CAMPAIGN BULLETIN

American Automobile Labeling Act Label Dealer Inventory

Reference: PM931, PC713

Date: October 22, 2019

Figure 3

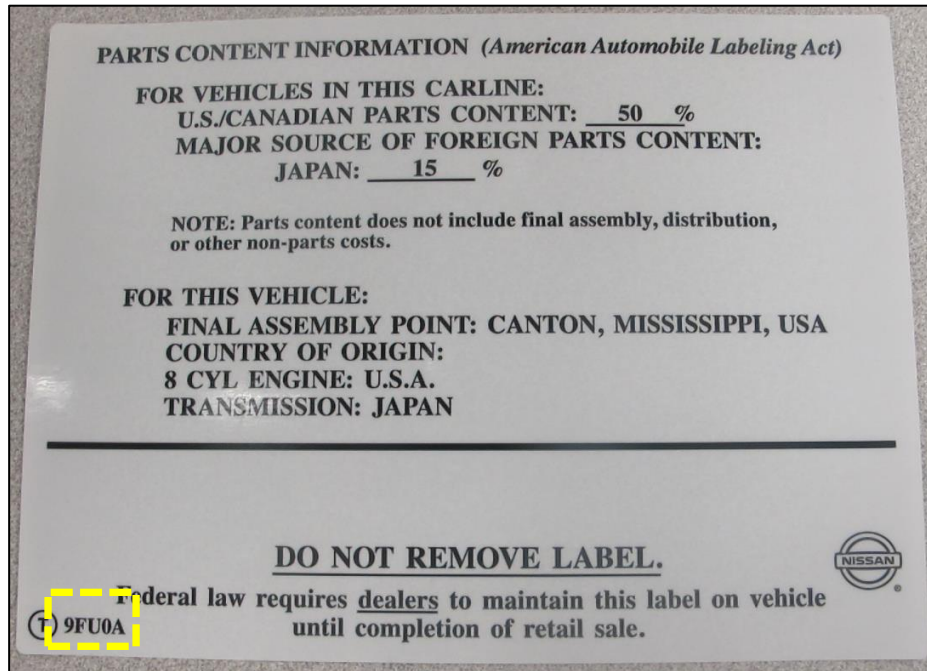
4. Verify the correct replacement label is available. (Figure 3)

- Check part number "9FU0A" on bottom left corner of label

Figure 5

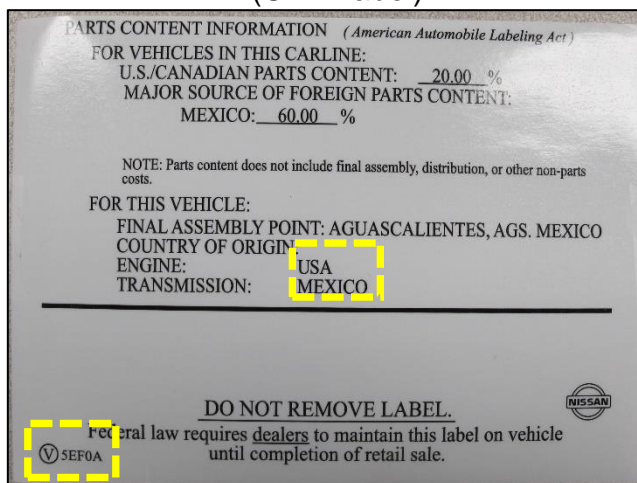
- Select the replacement "Parts Content Information label" that is applicable to the vehicle using the transmission type.
 - CVT equipped vehicle** uses label with transmission listed as "**MEXICO**" with part number "**5EF0A**" on bottom left corner per Figure 5
 - Manual equipped vehicle** uses label with transmission listed as "**SPAIN**" with part number "**5EF0B**" on bottom left corner per Figure 6

(CVT Label)

Figure 6

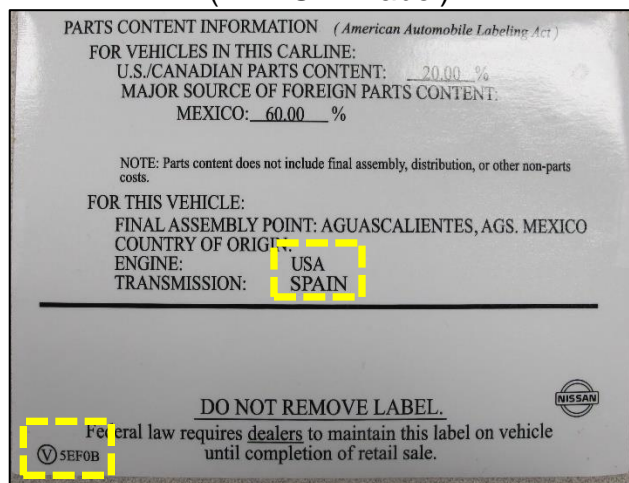
(MANUAL Label)
